PLANNING BOARD REPORT PORTLAND, MAINE

Seaport Lofts (Bay House Phase II)
101-121 Newbury Street and 40 Hancock Street
Level III Site Plan and Subdivision Review - Condition of Approval, Design Review
2013-179
113 Newbury Street, LLC, Applicant

Submitted to: Portland Planning Board Public Hearing Date: July 8, 2014	Prepared by: Nell Donaldson, Planner Date: July 3, 2-14 CBLs: 20-D-13, 14, 15, 32
--	---

Figures 2, 3, 4, and 5: October 2013 elevations.

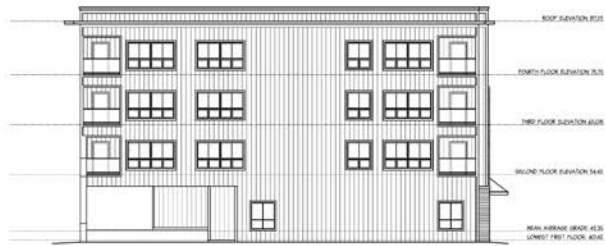
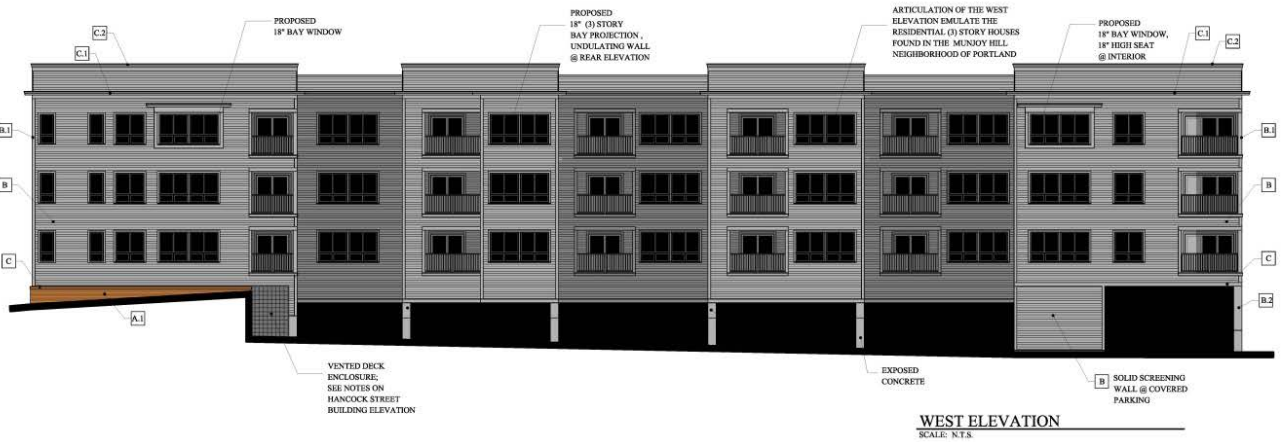
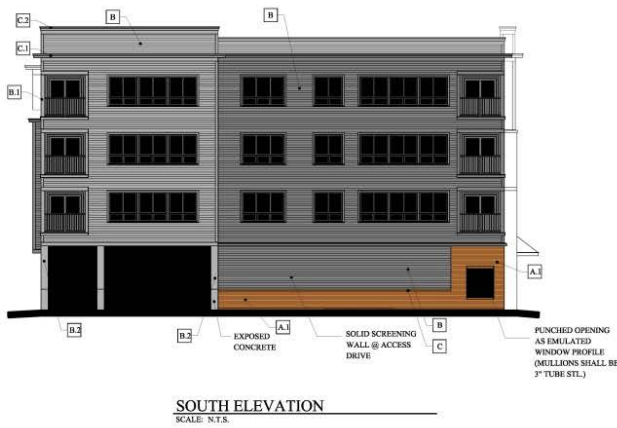
The applicant's final site plan submission, considered by the Board in October, included a set of design drawings intended to meet the above standards (*Figures 2-5*). These drawings represented one in a series of iterations meant to respond to city and Board comments. However, as noted above, the Board expressed considerable outstanding concerns regarding the design as presented, particularly with respect to articulation and compatibility. Given these

- *Awnings:* Responding to staff recommendations, the awning at Hancock Street has been redesigned to be consistent with that proposed at the Newbury Street entrance. Both entries are now depicted with a weathered copper awning hanging from stainless steel cables, a contemporary style requested by city staff.

- *Treatment of northwest corner:* The October 2013 design included an offset post at the northwest corner of the building which appeared unresolved. The applicant has modified the floor plan, adding area to the upper floor units, to eliminate this post and resolve this issue.

- *Soldier course:* At the October hearing, city staff recommended that the architect add a soldier course between the second and third floors of the Newbury Street façade in order to rationalize the change in composition there, where the townhouse units meet the upper story flats. The applicant considered this option, but elected not to introduce this soldier course and instead made other design changes to address massing and articulation concerns.

- *Windows & parapet:* The applicant has added windows and changed the window pattern on the Hancock Street, rear, and west facades, a modification meant to add visual interest and reduces the appearance of mass. The applicant has also introduced a parapet of varying heights on all facades. This feature is again intended to address concerns regarding massing and visual interest; the parapet helps to create the illusion of multiple distinct buildings rather than a single uniform one.

- *Articulation of the rear façade:* Maybe most significantly, and in response to Board concerns, the rear of the building is now articulated much like the front. In the October 2013 design, the rear elevation was entirely flat. This uniform wall has been replaced with an articulated one, which steps in and out as the Newbury Street one does. The architect has also added 4th story bay windows at the far ends of the rear façade, and a three story bay near the center of this elevation.

- *Materials & colors:* The applicant's final submittal also modifies the materials and colors of the previous design. The metal cladding originally proposed on the upper floors of the front façade and the entirety of the building's rear has been replaced with composite clapboards with a 5" reveal in two shades of gray. These two shades have been used in an alternating pattern in an effort to break up each façade. It should be noted that the applicant and architect expressed a preference for a typical Old Port red brick color; as such, the gray brick has been eliminated. Fiberglass windows are proposed with casing in black.

- *Metal screens:* Some additional detail has been provided on the composition of the metal screens on the Hancock and rear facades. These screens are shown in a grid pattern. Notes indicate that they will be metal painted black.
- *Exterior lighting:* Lastly, the applicant has provided cut sheets for a number of exterior lights, including sconces for the covered parking area, recessed downlights for the building entrances, and deck lights (*Attachment A*), as well as a lighting plan (*Plan 9*). As in prior submittals, updated site plans show sconces on the rear of the building as well, which are not depicted in this lighting plan. Revised cut sheets for these sconces have not been provided. A complete lighting submittal is outstanding. It is anticipated that lighting questions could be resolved under a further condition of approval, which has been proposed.

Figures 6, 7, 8, and 9: Revised elevations.
